HIROSE ELECTRIC CO., LTD.
2-6-3 Nakagawa Chuoh, Tsuzuki-ku, Yokohama, JAPAN

Product Change Notification

■Product list PCN2022-20_SR30 series specifications changed (Spacer deleted)

(Attachment 2) About the changes

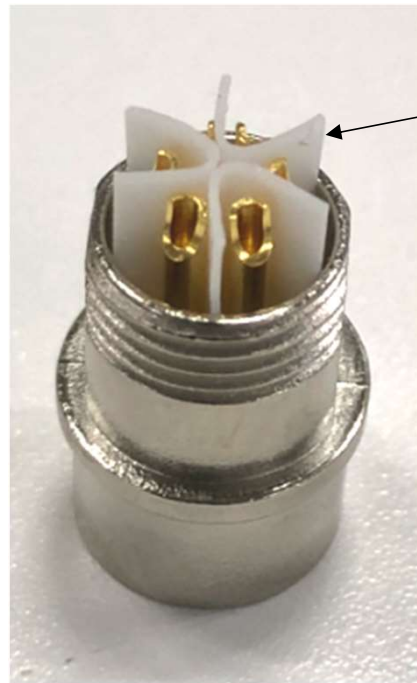
*1 The red marking that used to indicate the position of the terminal hole (for terminal No. 1) on the insulator will also be eliminated.

Eliminates the spacers that used to be placed between adjacent terminals.
